NC-107 Report

NOVEMBER 2019

ASHEVILLE DESIGN CENTER

Several of the Asheville Design Center consultant team members, from Traffic Planning & Design and Friction Shift Projects, reviewed the NCDOT preliminary plans for NC-107 (Titled: 'R5600_RDY_PRELIMINARY_DESIGN_MAP', Dated: January 2019). Our review of the NCDOT preliminary designs for the intersections of NC-107/US-23 and NC-107/Webster Road yielded several pedestrian and bicycle safety related treatments for consideration at these intersections. The team formulated these recommendations with key goals in mind, which were informed by the community engagement portions of this project:

Figure A: NC-107 at US-23 Intersection Shown with References to this Memo.

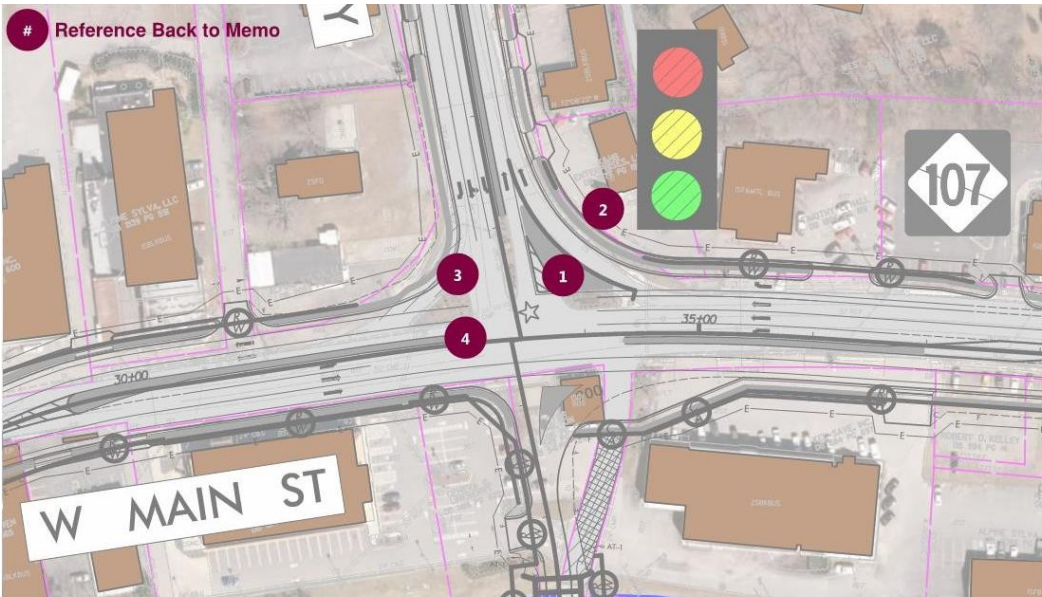
Vertical Traffic Calming Elements: For visual location of the following references, see Figure A.

- Consider reconfiguring the island at Location #1 in Figure A: The NCDOT preliminary design accommodates relatively high travel speeds for the free flowing right turn movement from NC-107 onto US-23 Business northbound. It may be feasible to reconfigure this right turn design to slow traffic for pedestrian safety purposes. As shown in the attached resource from University of Texas, there are several compound radius alternatives that encourage slower speeds and increase pedestrian visibility. Additional benefits and considerations to this design are as follows:

- Reconfiguring the island would also provide a pedestrian refuge, reducing pedestrian exposure and potentially calming traffic. Under this scenario, this island would require pedestrian signals with properly placed accessible push buttons.

- Alternate channelized right turn designs could potentially reduce the right-of-way impact, pending further vetting in design (See Figure A, Location #2).

- Consider adding an island (Figure A, Location #3) at the northwest corner of the intersection: There may be an opportunity to add a pedestrian refuge island at this location. This could present an opportunity to reduce pedestrian crossing distances and provide space for pedestrian signal equipment.

- Consider extending median for pedestrian refuge area (Figure A, Location #4): The design team identified this median for further investigation. This extension could provide a small pedestrian refuge area and could calm traffic as it would require slower turning speeds.

Figure B: NC-107 at Webster Road Intersection Shown with References to this Memo.

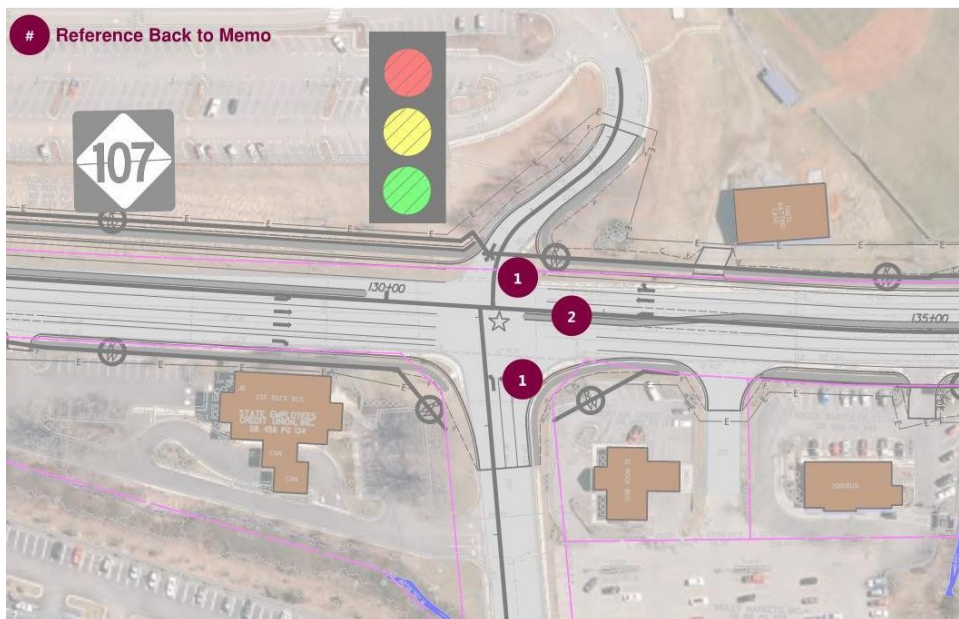
Vertical Traffic Calming Elements: For visual location of the following references, see Figure B.

- Consider adding an island: At the southwest and southeast corners of the intersection (See Figure B, Locations #1), there may be an opportunity to add pedestrian refuge islands. The recommendation could help shorten pedestrian crossing distance and reduce pedestrian exposure to traffic.

- Consider a two-stage crosswalk (See Figure B, Location #2): The pedestrian crossing distance on the southern leg of NC-107 is wide and has a skewed crosswalk alignment from Webster Road to Alexander Street. Further investigation into a two-stage crossing is recommended for several reasons:

- This design option would allow for better crosswalk orientation (closer to 90 degrees) for visually impaired users
 - Enhanced pedestrian safety with a two-stage crossing and pedestrian refuge island

For this option, the pedestrian refuge island would need to be a minimum of 8 feet wide and would require pedestrian channelization fencing to prevent jaywalking. Photo 1 shows an example of a two-stage crosswalk from FHWA’s webpage.
